**A. INTRODUCTION**

This chapter summarizes and responds to all substantive comments on the Draft Environmental Impact Statement (DEIS), issued on September 5, 2008, for the proposed 363-365 Bond Street project. Oral and written comments were received during a public hearing held by the New York City Planning Commission (CPC) on January 7, 2009. Written comments were accepted from issuance of the DEIS through the public comment period, which ended January 20, 2009.

### **363-365 Bond Street FEIS**

Figure 27-1

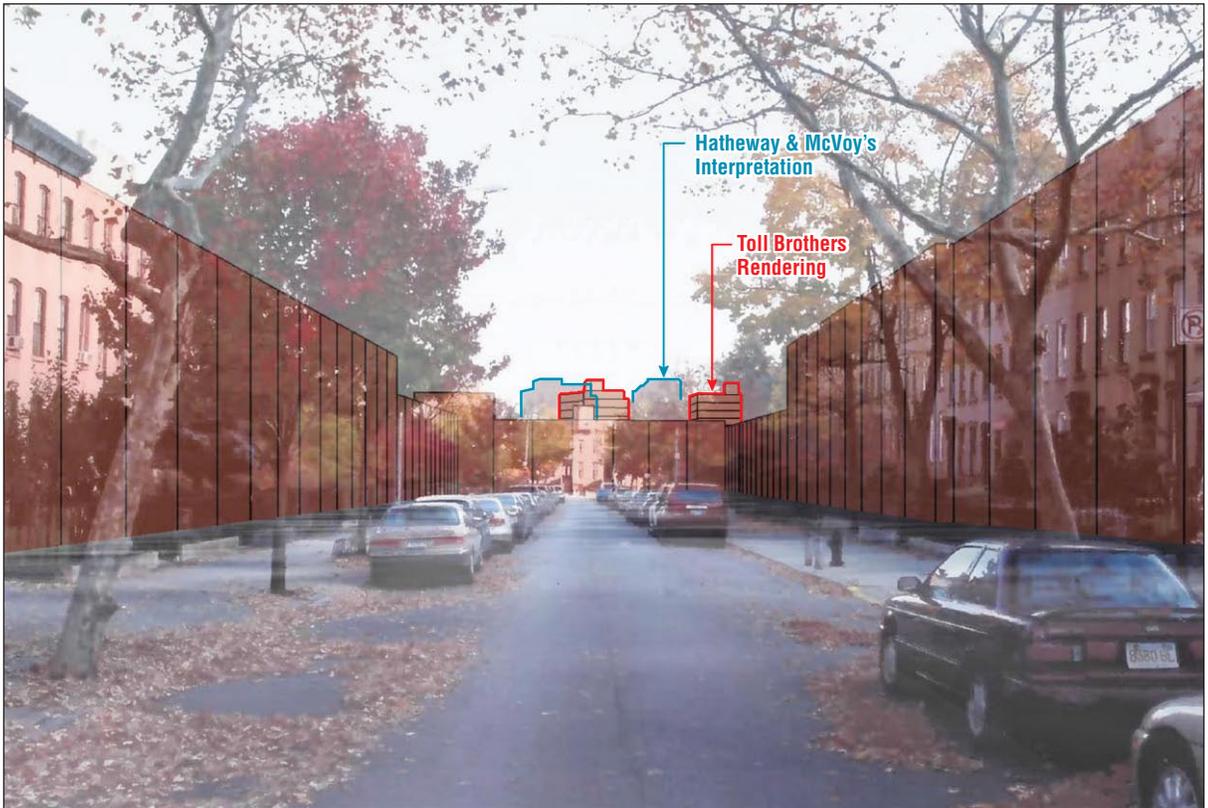
**Comment 1-2:** The rendering from across the canal (Figure 1-11c) inserts the project into the existing photo at a significantly smaller size than it would appear in reality. Measured against the existing buildings in the view, the 12-story portions scale to be approximately 85 feet high instead of the proposed 124 feet and 8 inches and they are shown narrower than they would appear in this view. The rendering also omits the elevator bulkhead which scales to be approximately 145 feet in the section provided in the DEIS. (Hatheway/McVoy)

**Comment 7-2:**

The 400-foot depth of this site is not enough to lessen the impact of a transition from 2- and 3-story buildings to 12-story buildings. (McVoy)

**Response 1-2:** Figure 1-11c in the DEIS was included for illustrative purposes, and reflects an artist's interpretation of the proposed buildings. The rendering showed general building design, massing, and project layout. The methodology used to develop the commenters' rendering is unclear (see FEIS Appendix I for the submitted written comments on the DEIS). To address the comment, Figure 1-11c has been further refined in the FEIS based on current survey and topographical data. The revised image also accounts for the setback from the water's edge and the 125 foot height limitation. The revised rendering is not significantly different from that which appeared in the DEIS. The DEIS also included measured drawings and accurately scaled site plans showing the heights, including the elevator bulkhead (see Figures 1-5 through 1-10). Based on all these data, it was the conclusion of the DEIS, and remains the conclusion of this FEIS, that the proposed project would not have any adverse impacts with respect to urban design and visual resources.

An additional figure is included to the Response to Comments chapter (see Figure 27-1), which illustrates the inaccuracies of the massing presented by the commenter during the public review process as compared to the massing actually proposed by the applicant. The conclusion of Chapter 8, "Urban Design and Visual Resources," of the DEIS with respect to urban design and visual resources remains unchanged (i.e., no adverse significant impacts from the proposed project).

**Response 7-2:** The City’s future planned rezoning proposal for the Gowanus area is outside the scope of this application. As discussed in Chapter 2, “Land Use, Zoning, and Public Policy” the City’s draft rezoning proposal is expected to be refined with on-going community input and may be put forth formally in a Draft Scope of Work for the purposes of preparing an EIS in February 2009. However, the proposed project has been determined to be consistent with the land uses and building heights that would be allowed per the Framework for the Gowanus Canal (see Chapter 2, “Land Use, Zoning, and Public Policy”). In addition, the proposed project was reviewed by SHPO and LPC and it was determined that the proposed project would have the context or visual character of the Carroll Gardens Historic District, and would have no adverse impact on the resource (see Chapter 7, “Historic Resources).
